# **Impact Area Groundwater Study Program**

### **Demo 1 Groundwater Operable Unit**

#### **Response to Comments Letter and Memorandum of Resolution**

**Re: Impact Area Groundwater Study Program (IAGWSP)  
USEPA Region I Administrative Orders SDWA 1-97-1019 and 1-2000-0014  
Response to Comments (RCL) on the Revised Draft Feasibility Study  
Demo 1 Groundwater Operable Unit**

**Alternative 6 -  
 Additional Alternative B  
 Conceptual Layout**  
 Remedial Design Work Plan  
 Demo 1 Groundwater Operable Unit

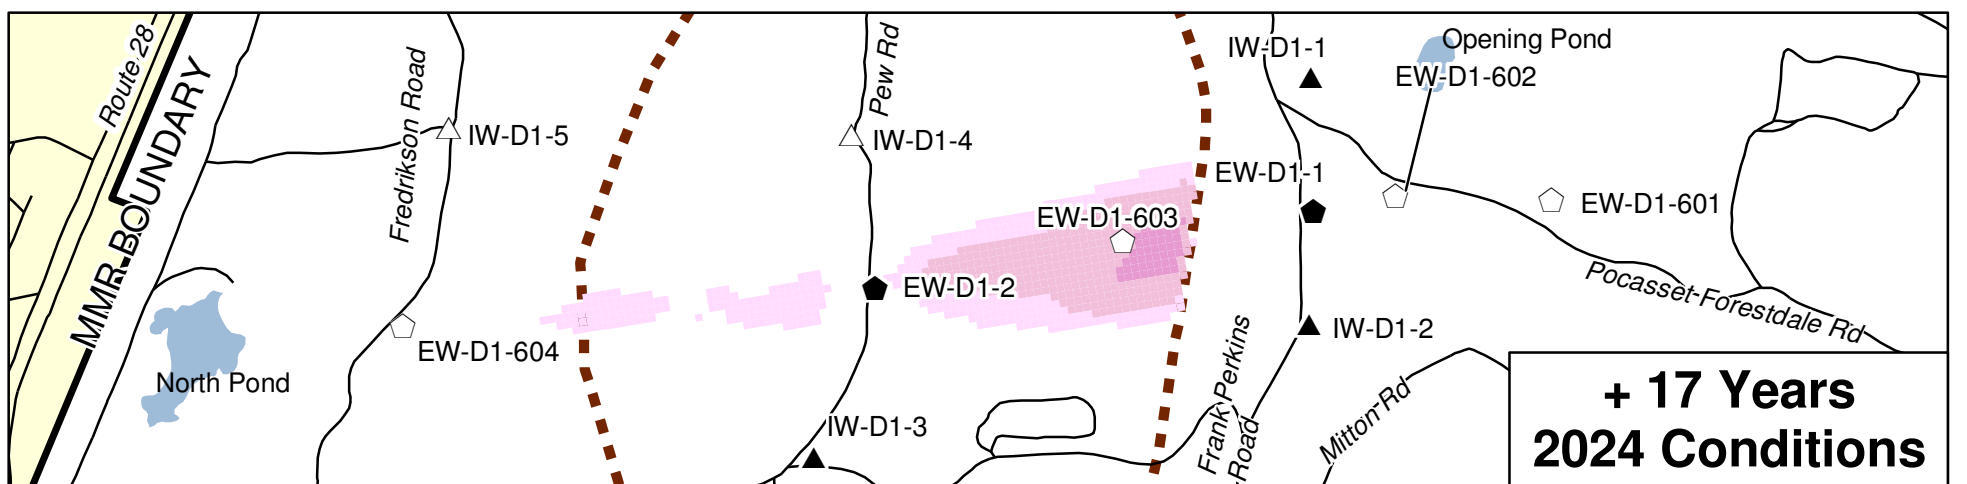
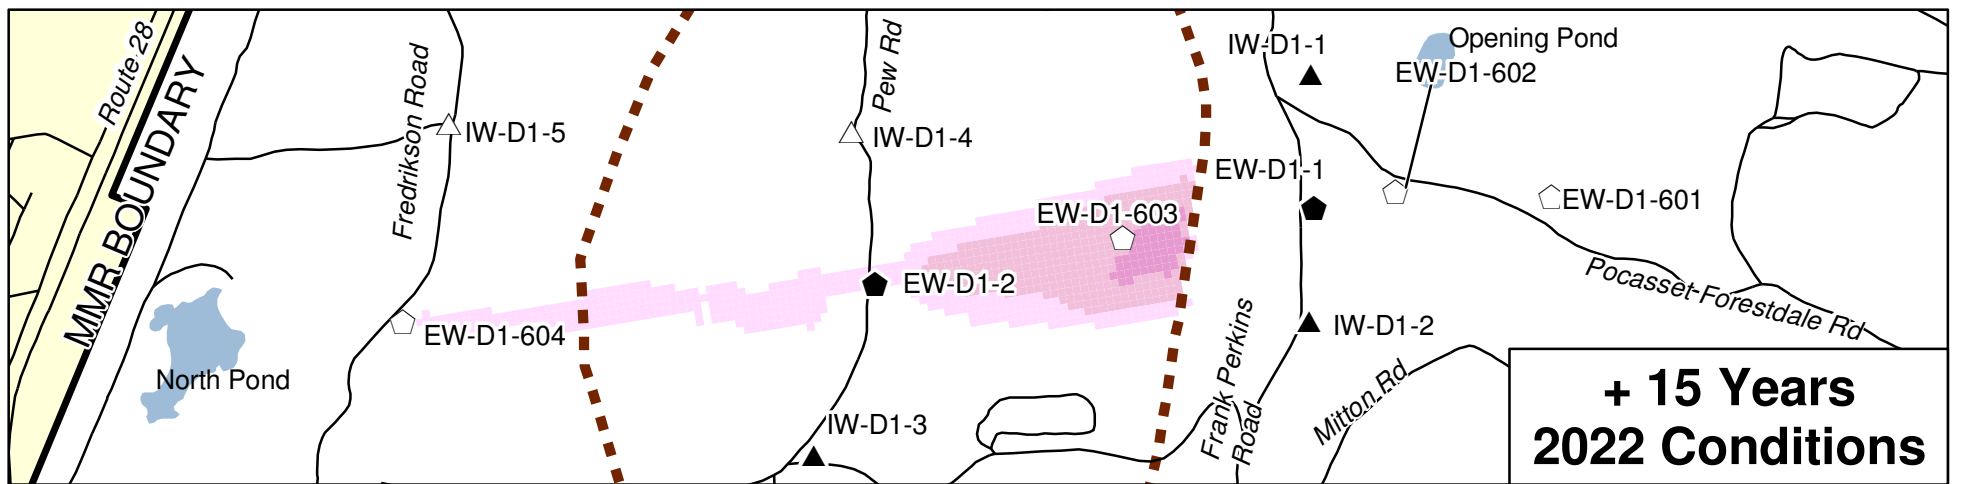
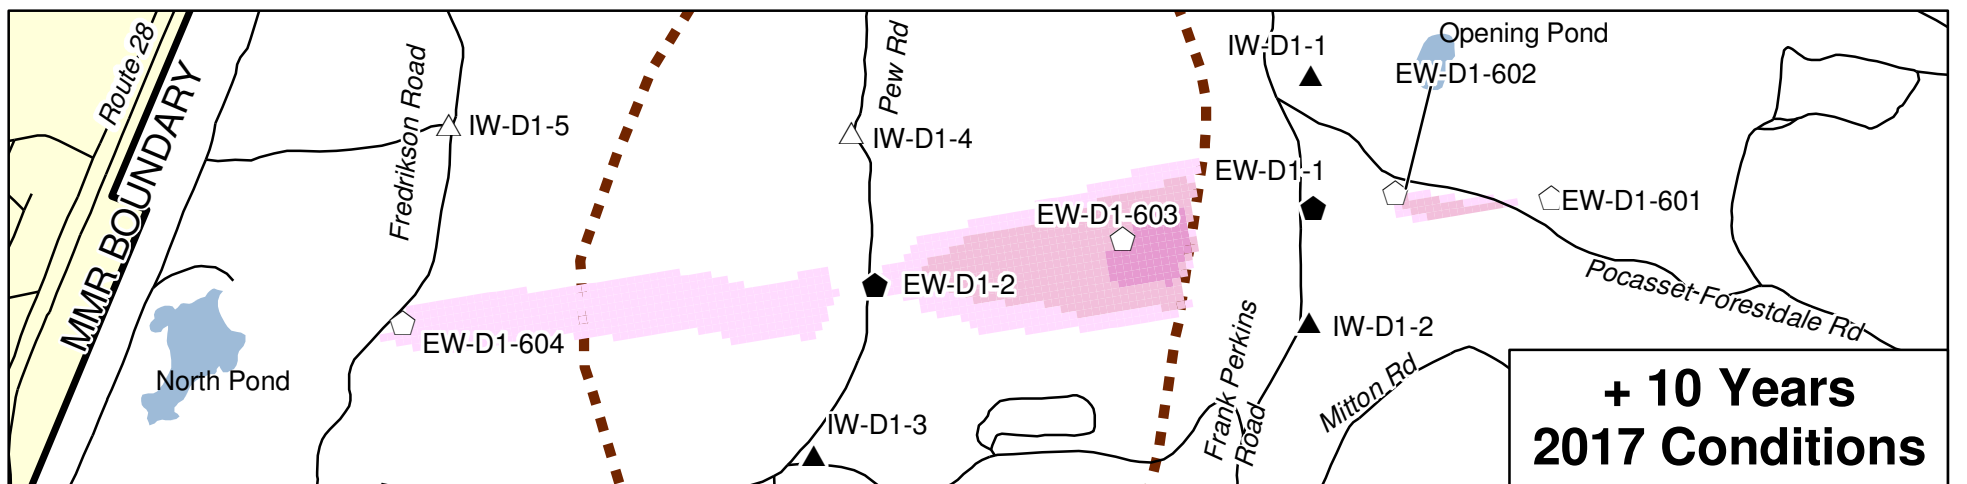
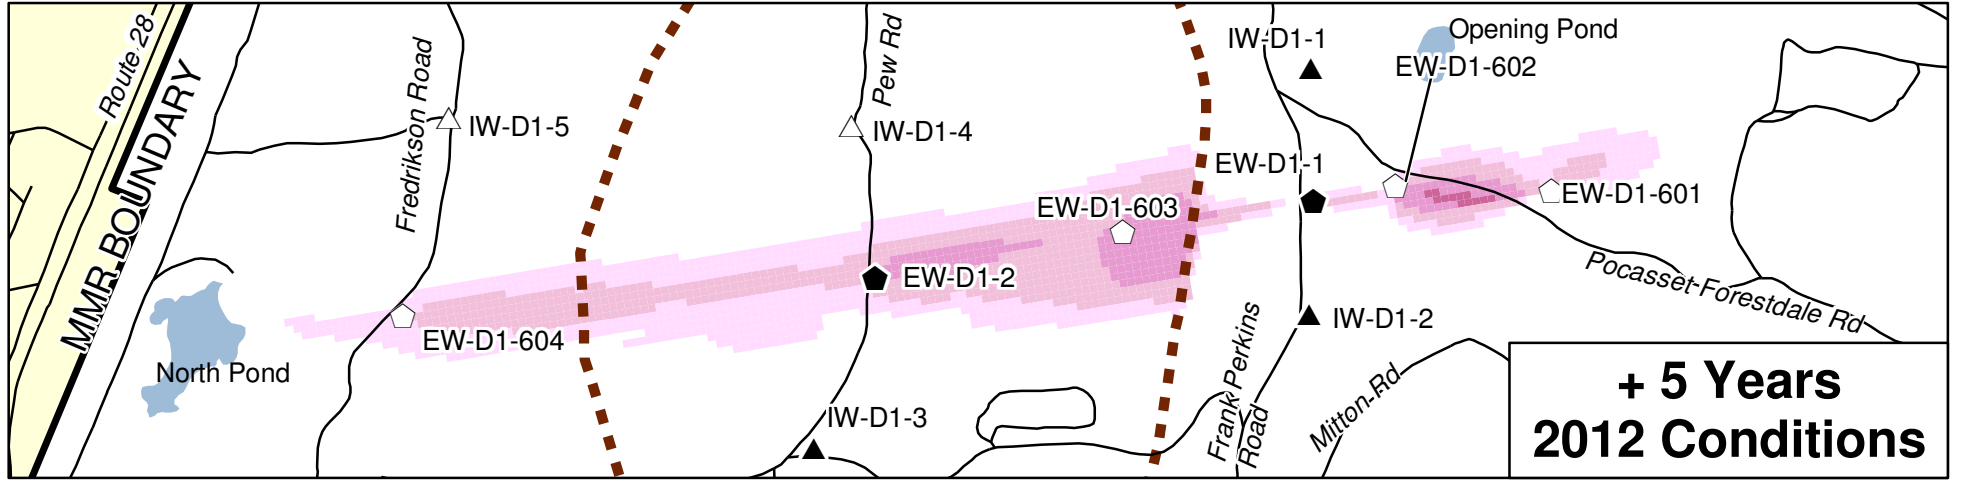
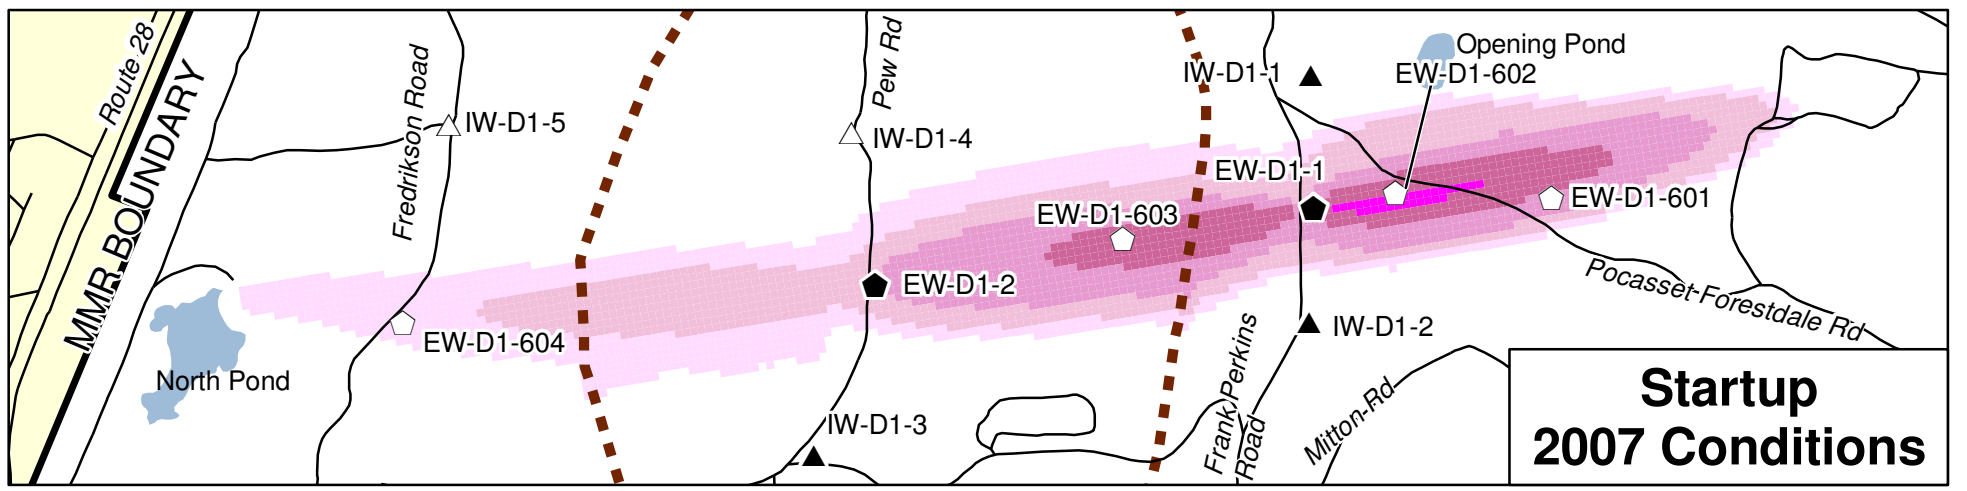
**EPA Comment 4 (04/19/05)** Figure F3-1: a) Add pipelines along Fredrikson Rd between the treatment facility and the reinjection well (IW-D1-5). b) Please clarify why reinjection well was placed to the north of the Fredrikson Road treatment facility rather than the south.

FIGURE  
 F3-2

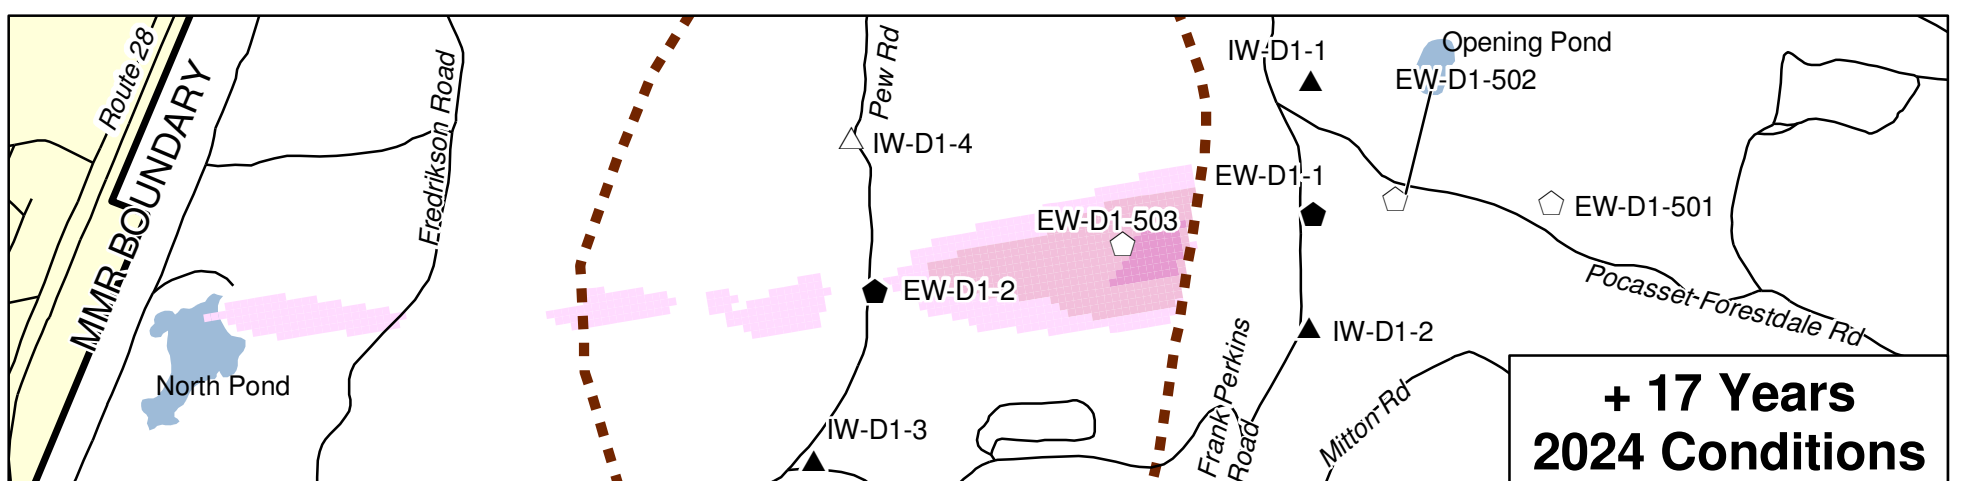
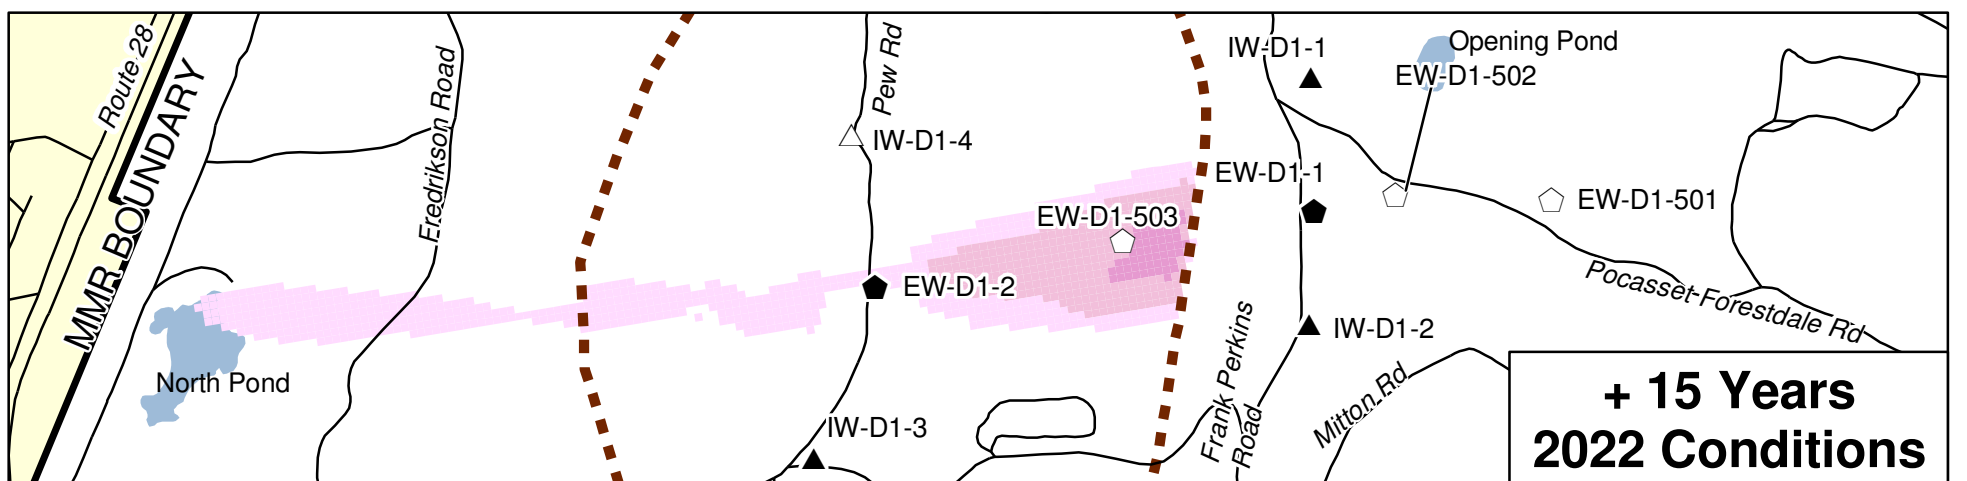
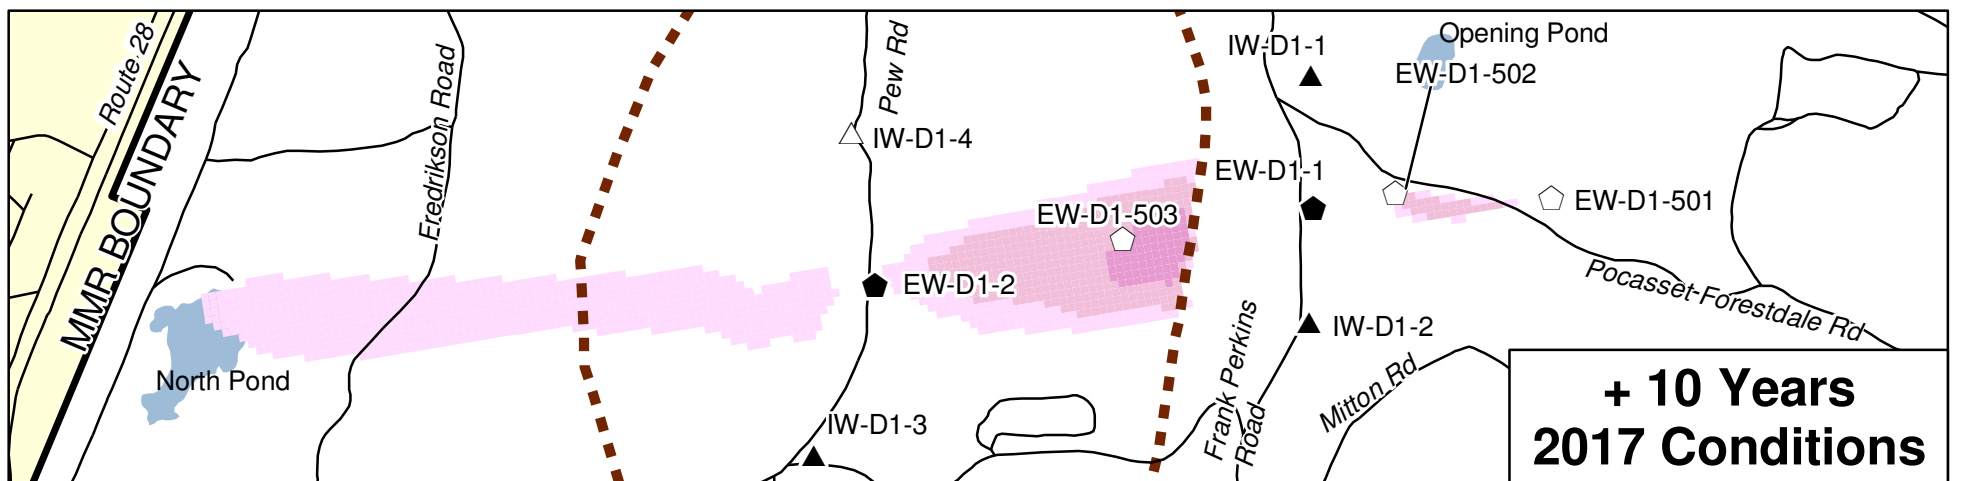
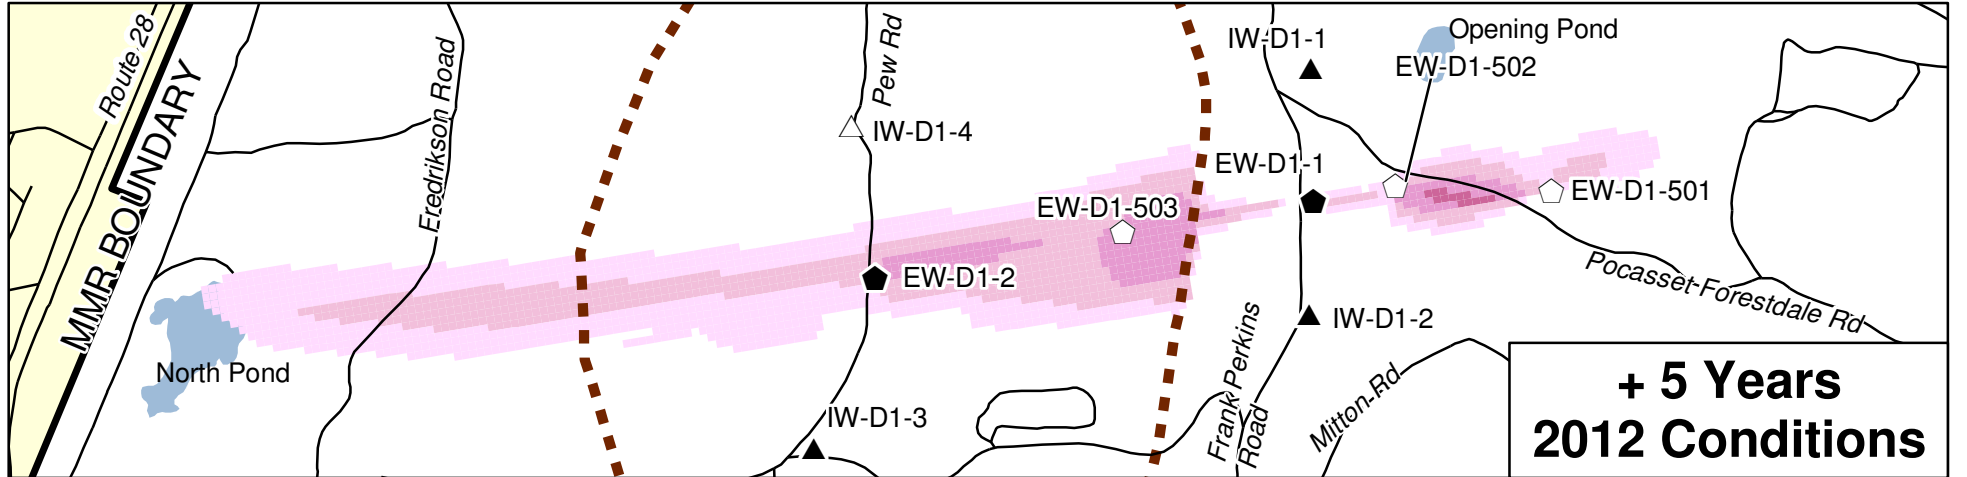
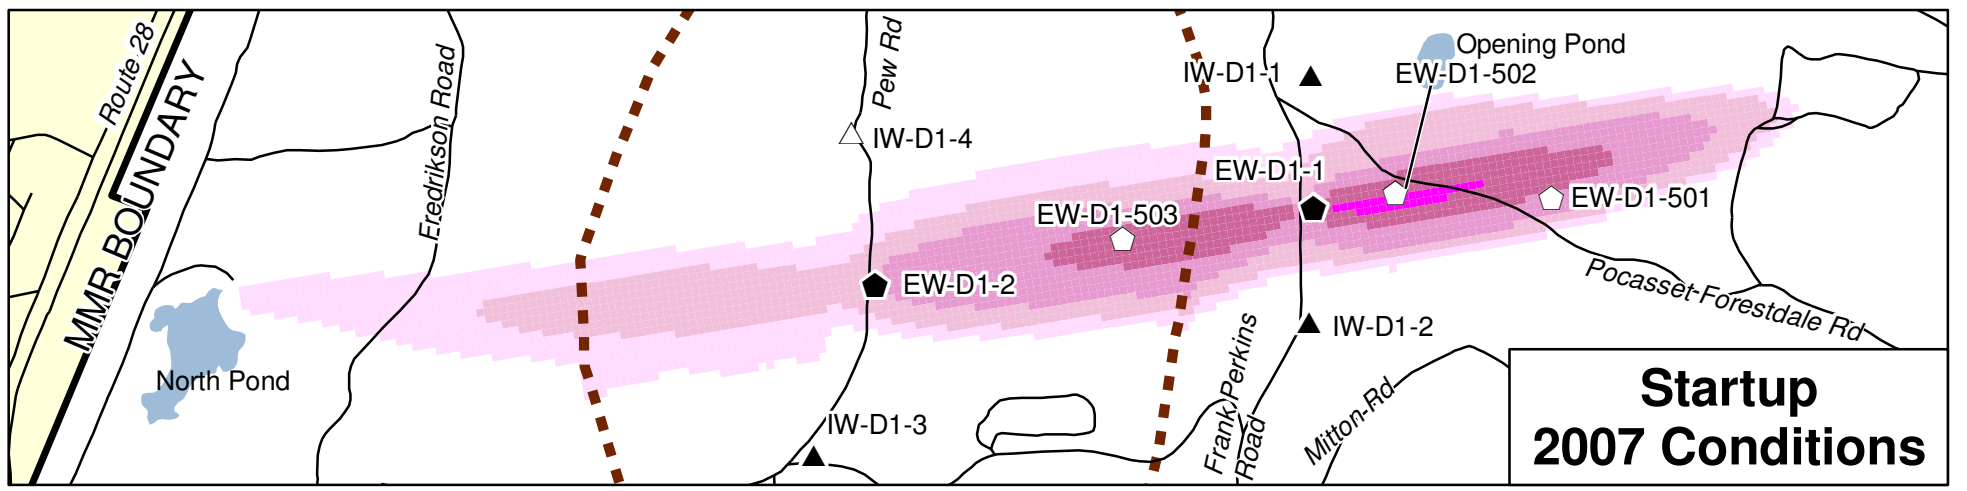
**EPA Comment 1 (04/19/05)** Page F-6, Section 3.0, 2<sup>nd</sup> and 3<sup>rd</sup> Paragraph: Please discuss why the images showing the plume at +10, +15, and +17 years in Figure F3-2 and F3-3 shows Perchlorate persisting in the area around EW-D1-603 while the text and tables present the conclusion that cleanup to 1 ppb is achieved.

*Figures F3-2 and F3-3 (and also F3-4) portray maximum predicted concentrations within the 3-dimensional subsurface groundwater simulation projected onto the map plane. The maximum concentration is projected irrespective of depth. In the case of Demo 1 (and elsewhere on MMR) varying types of soil are present including both highly permeable sand and gravel aquifer materials and poorly permeable silts and clays that constitute an aquitard of limited local extent. The presence of this aquitard is influencing the vertical movement of the plume, essentially preventing downward migration that would result from the prevailing downward hydraulic gradients. On figures F3-2 and F-3-3, the estimated lateral extent of the interpreted aquitard is indicated with a dashed brown line.*
